SUPPLEMENT A
HOLTEC REPORT HI-89399

New York Power Authority

JAMES A. FITZPATRICK NUCLEAR POWER PLANT
Docket No. 50-333

SUPPLEMENT A
HOLTEC REPORT HI-89399

FIGURE 2: MODULE LAYOUT

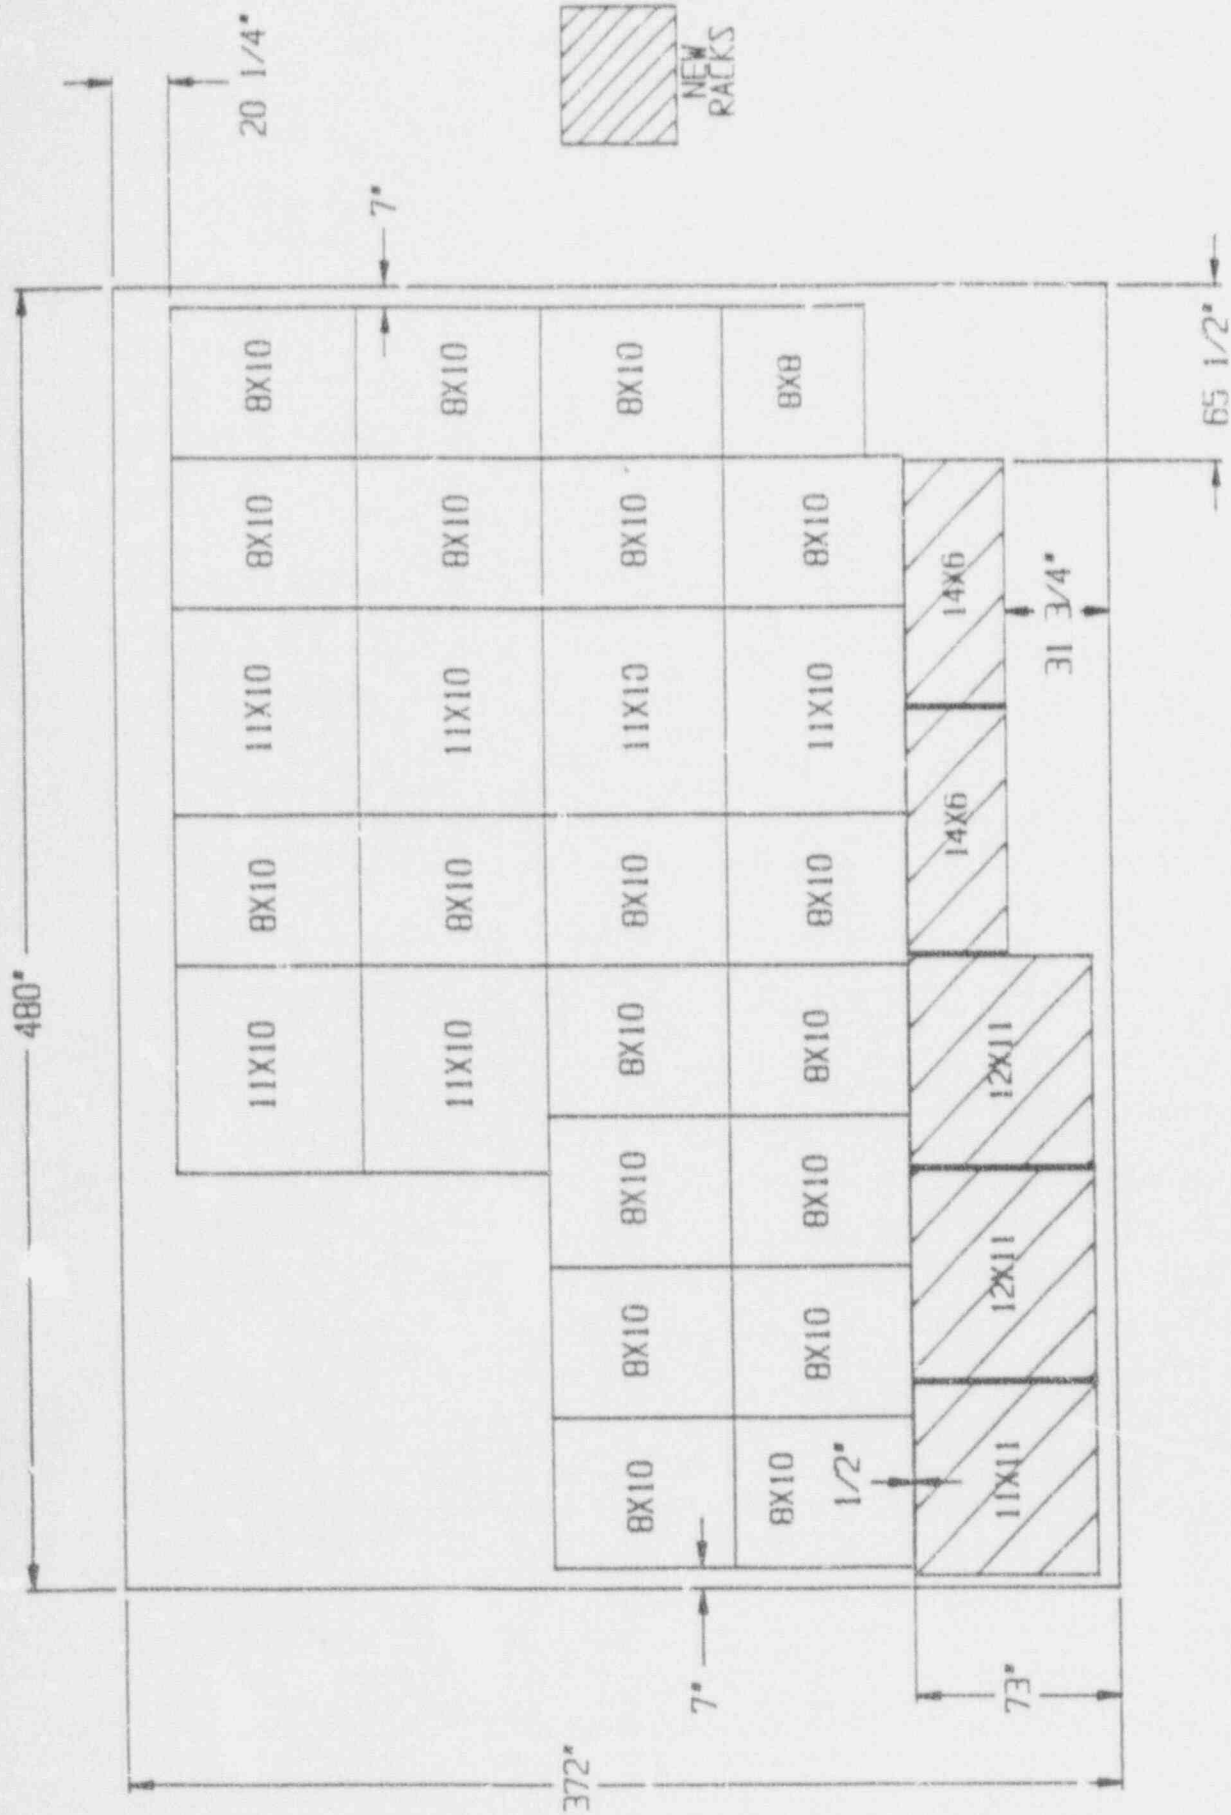
A dimensional survey of the pool indicated that the rack-to-wall gap at certain locations, and the gap between the existing racks and the new rack array, are slightly reduced. Figure 2.1 in the original licensing application is herein modified to reflect the new dimensions and is relabelled as Figure 1. A review of NYPA's licensing submittal document indicated that thermal/hydraulic (Section 5) and structural considerations (Section 6) required reassessment and re-evaluation. This submittal documents results of the reanalysis, and provides results in conformance with the actual spent fuel pool dimensions and rack spacing.
